S.D. Ireland Companies
Precast Division

Attention:	Ted Luck	Date:	6/2/2014
Company:	Luck Brothers	Job Name:	Warren BRF 013-4(32)
Address:		Job Number:	SDI #14046
City, St, Zip:		Regarding:	RFI #1
Ph: / Fax:

Notes/Remarks: Request for omission of rebar

STRUCTURE	VTAOT WARREN BRF 013-4(32) PRECAST
LOCATION	BRIDGE 166 ROUTE 100 (MINOR ARTERIAL) WARREN, VT
ARCHITECT	
ENGINEER	
CUSTOMER	S.D. IRELAND CONCRETE CONST. CORP.
DRAWN BY ED	DATE 2/18/14
DFI #	8756
DRAWING COVERS	ABUTMENT #1 DUAL COATED REINFORCING
DRAWING #	C

Elevation View A-A

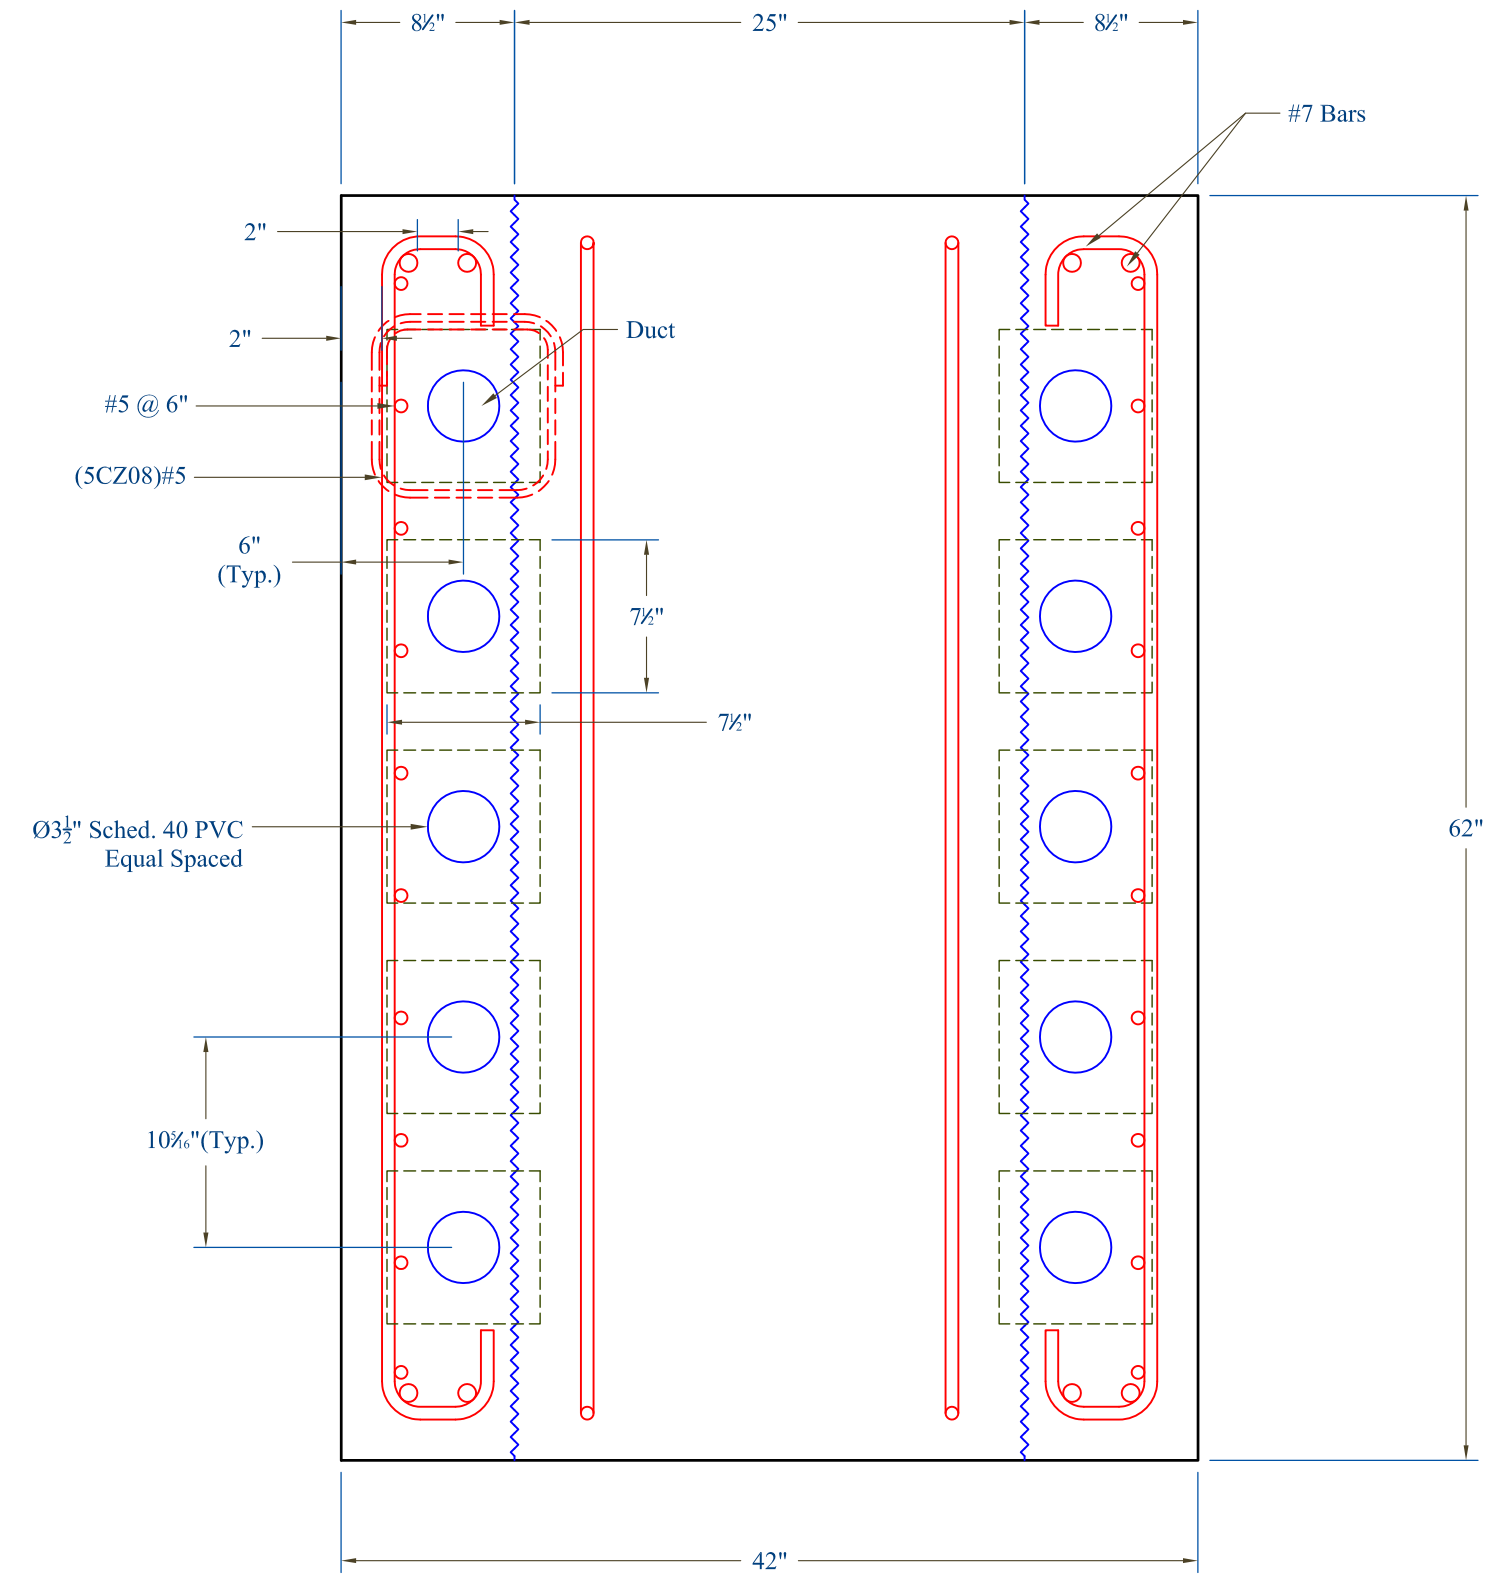
On the 17th of April our dual coated reinforcing supplier provided a reinforcing detail addressing the resolution of rebar 7CZ01, 02, 03, and 7CZ04, as suggested by MacFarland Johnson. See attached.
Our fabricator inadvertantly ADDED rebar 5CZ08. As focus was on the above change and acceptance this added rebar was overlooked. Attached
It is requested we be allowed to "eliminate" this interfering bar. This was bar not designed into the abutment to begin with.
